FINAL PRODUCT/PROCESS CHANGE NOTIFICATION #16669Generic Copy

Issue Date: 23-Jun-2011

TITLE: Qualification of Serial I2C EEPROM devices CAT24C128 and CAT24C256 for fabrication at ON Semiconductor's Gresham, Oregon Wafer Fab

Current OKI die CAT24C128 Rev B

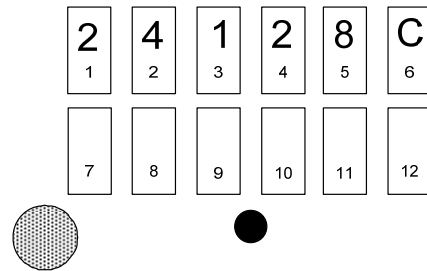
- 1: Assembly location code
- 2: Leadfinish (NiPdAu)
- 3: Product Revision
- 4-10: Device name
- 11: Temperature range
- 12: Production Year
- 13: Production Month
- 14-17: Assembly lot number

New Gresham die CAT24C128 Rev C

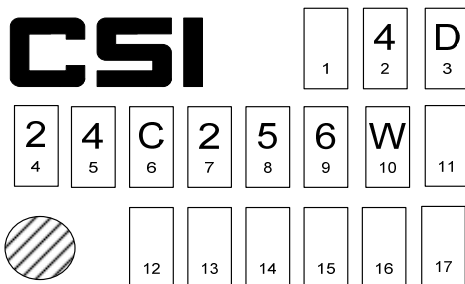
- 1-5: Device name(5 char)
- 6: Production Revision
- 7: Assembly location
- 8: Production Year
- 9: Production Month
- 10-12: Assembly Lot Number

Current OKI die CAT24C128YI-G

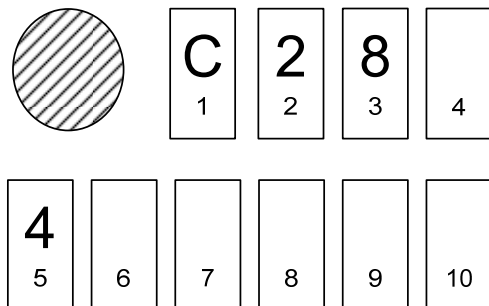
- 1-3: Device name
- 4: Assembly location code
- 5: Leadfinish (NiPdAu)
- 6: Production Year
- 7: Production Month
- 8-10: Assembly lot number

New Gresham die CAT24C128YI-G Rev C

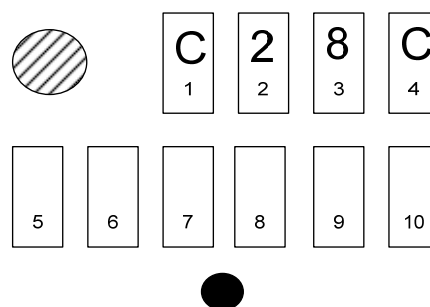
- 1-3: Device name
- 4: Product Revision
- 5: Assembly location code
- 6: Production Year
- 7: Production Month
- 8-10: Assembly lot number
- :Pb-free microdot

Current OKI die CAT24C128LI-G

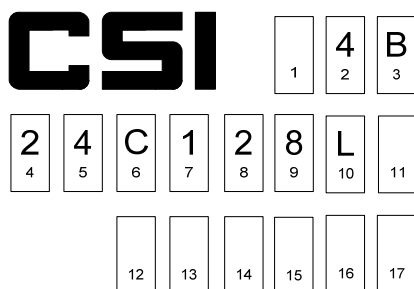
- 1: Assembly location code
- 2: Leadfinish (NiPdAu)
- 3: Product Revision
- 4-10: Device name
- 11: Temperature range
- 12: Production Year
- 13: Production Month
- 14-17: Assembly lot number

New Gresham die CAT24C128LI-G Rev C

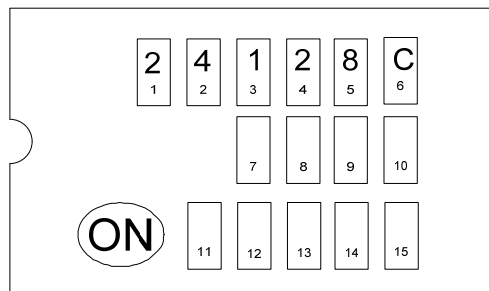
- 1-5: Device name
- 6: Product Revision
- 7: Assembly location code
- 8-10: Assembly lot number
- 11-12: Production Year
- 13-14: Production Week
- 15: Pb-free designator
